STATE OF MAINE
DEPARTMENT OF TRANSPORTATION
16 STATE HOUSE STATION
AUGUSTA, MAINE 04333-0016

November 18, 2022
Subject: Bridge Rehabilitation
State WIN: 021751.01
Location: **Boothbay Harbor & Southport
Amendment No. 5**

JACKING ELEVATION

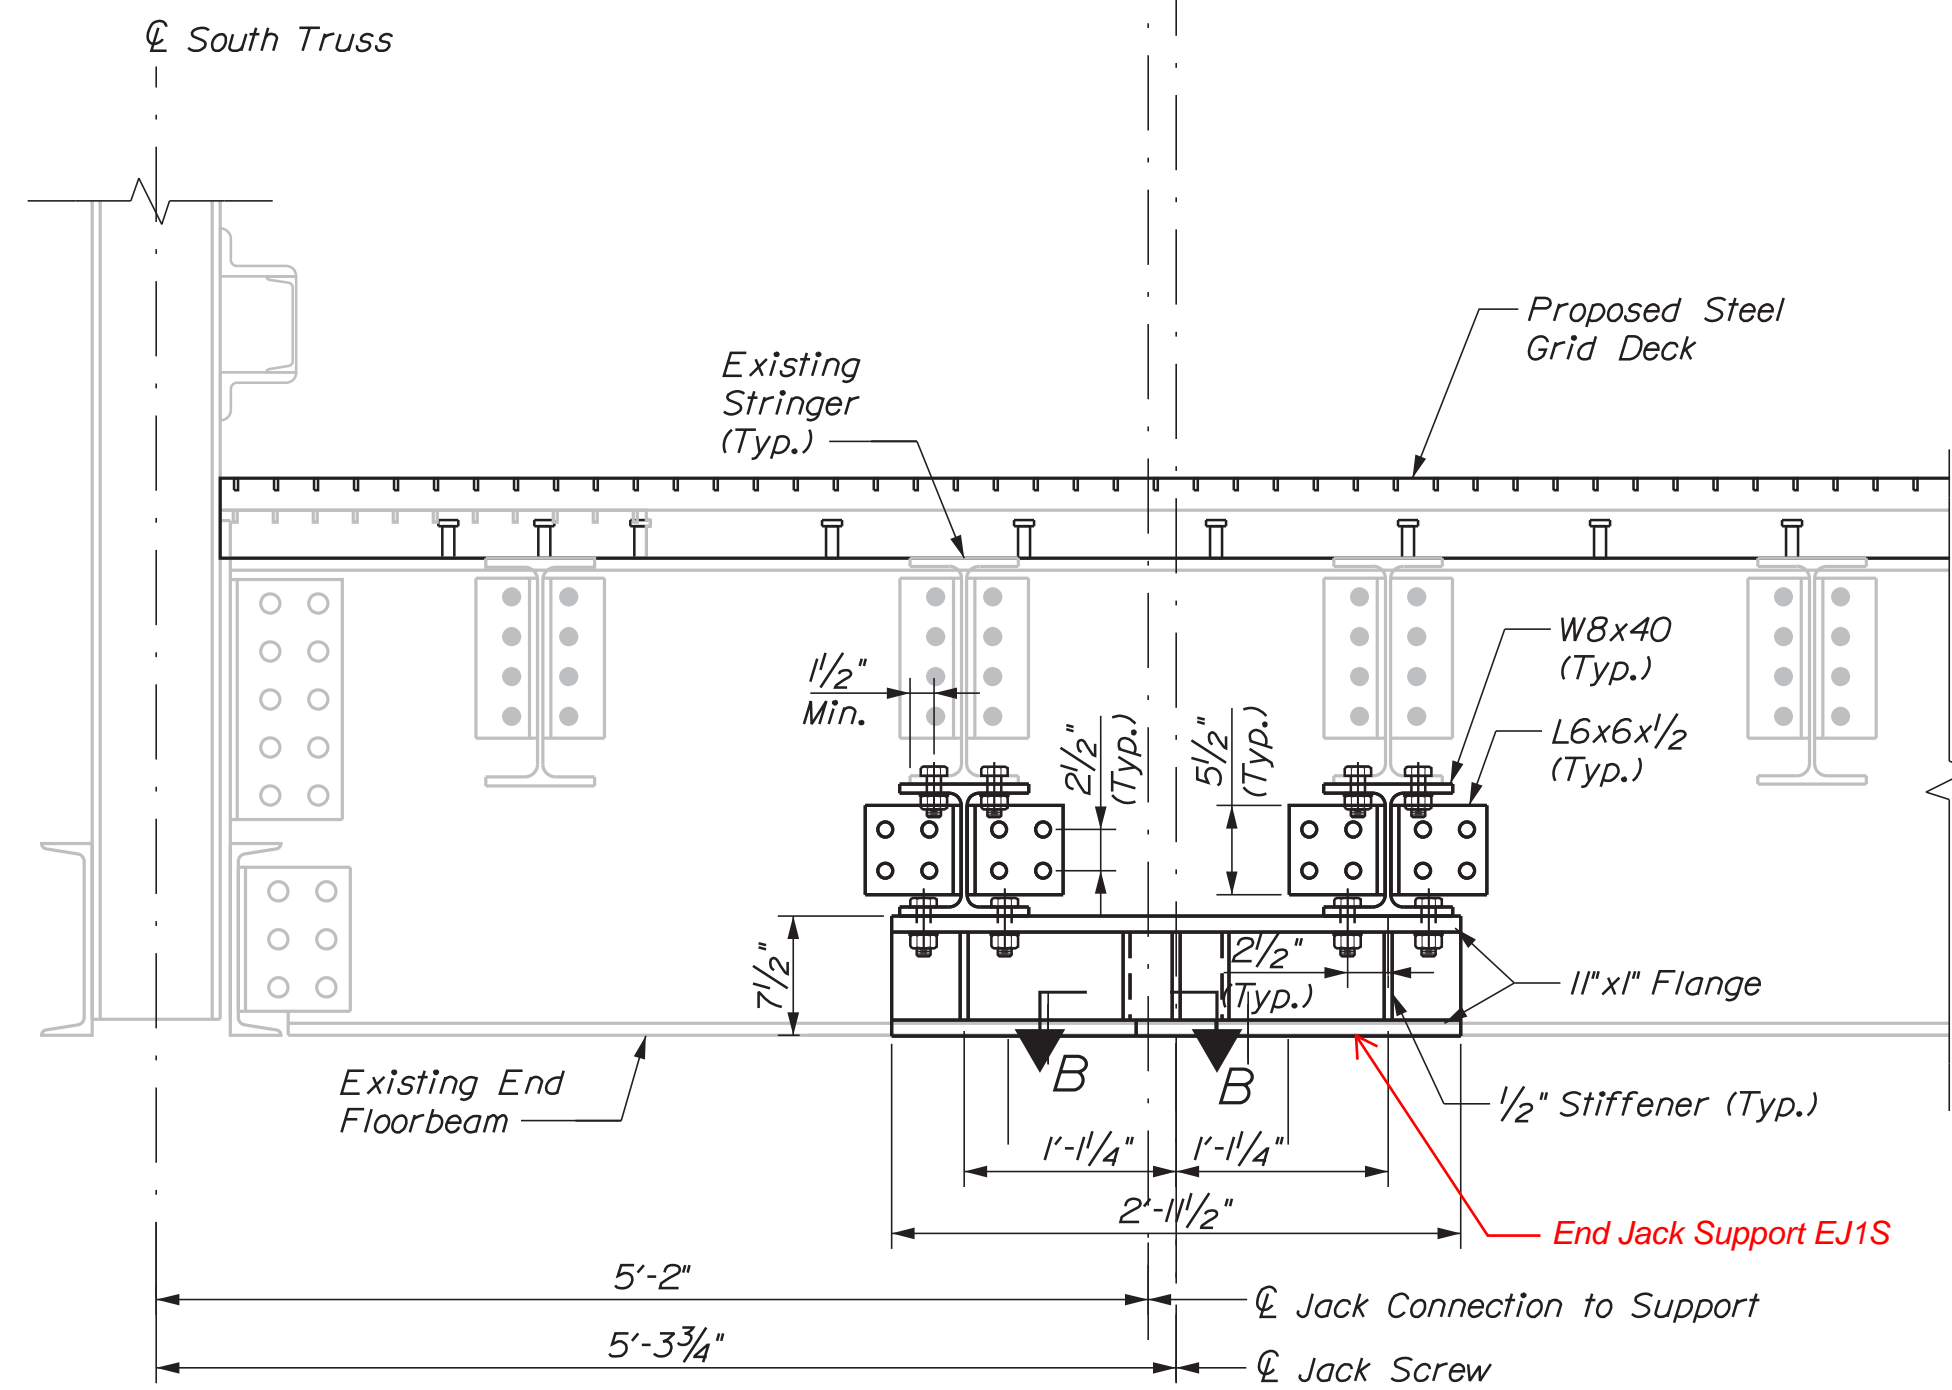
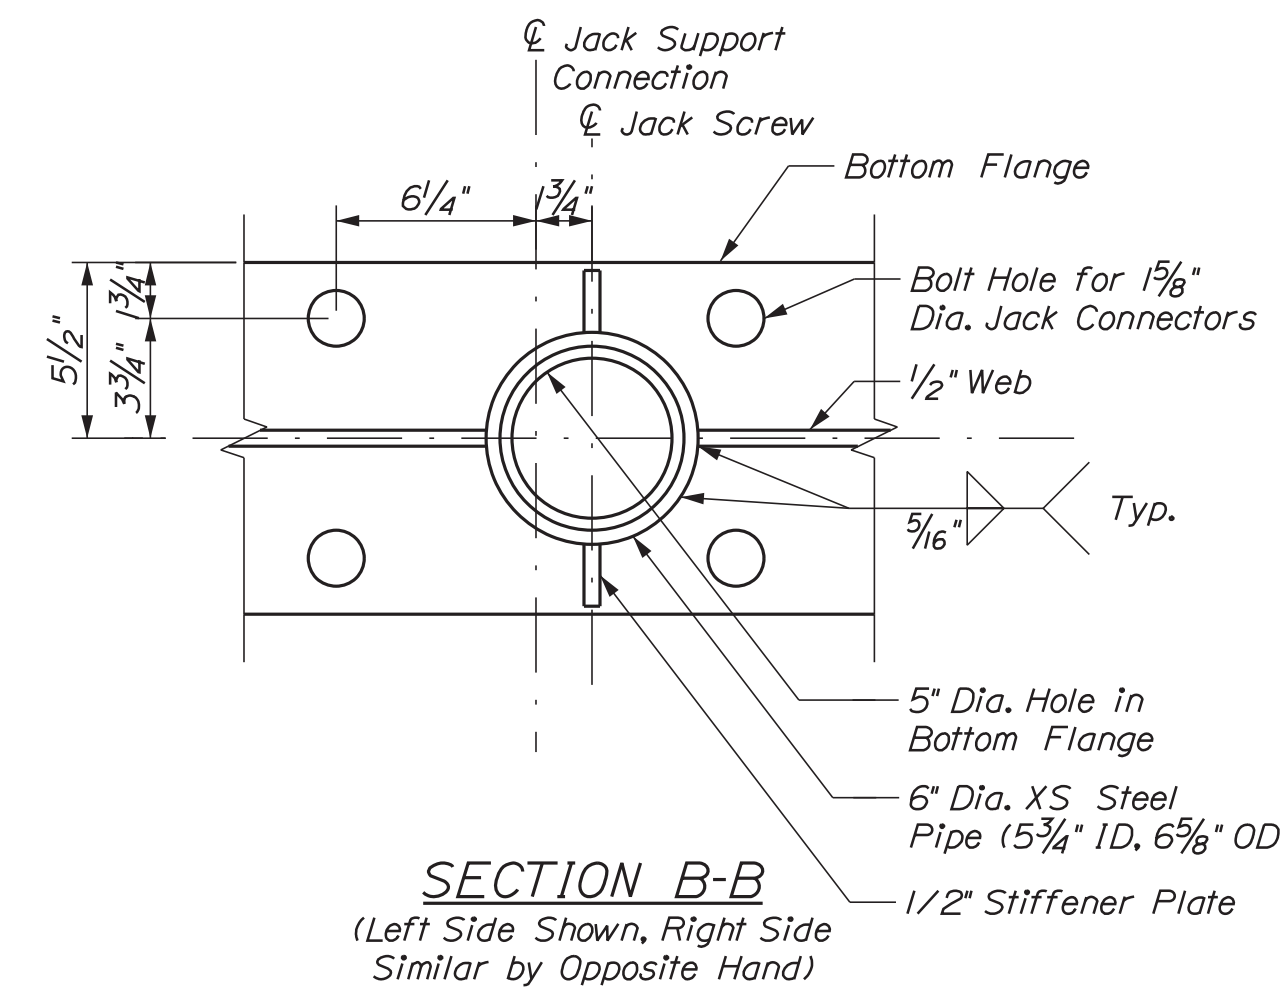
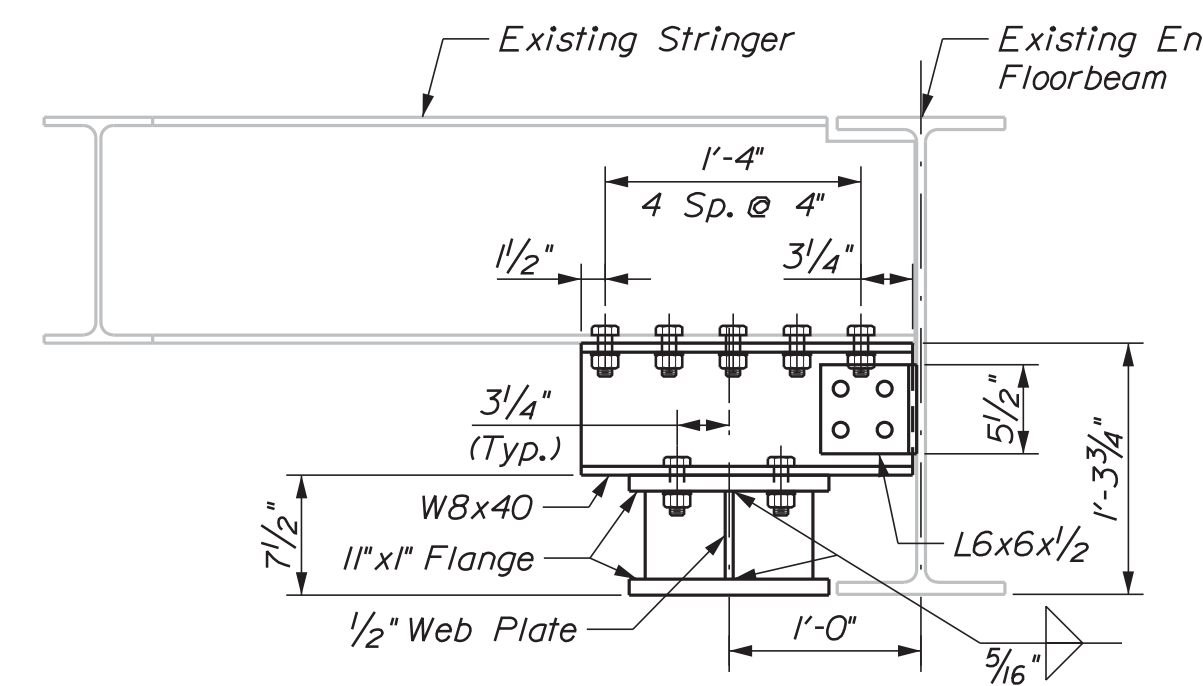
Question: Please refer to drawing M11 Elevation, the call out “End Stop (See note 8)” does not appear to be correct. Please clarify.

Response: Refer to drawing M11 Rev. 1 on which the End Jack callouts and Note 8 were revised. Sheet 32 of 48 has been updated to reflect these changes.
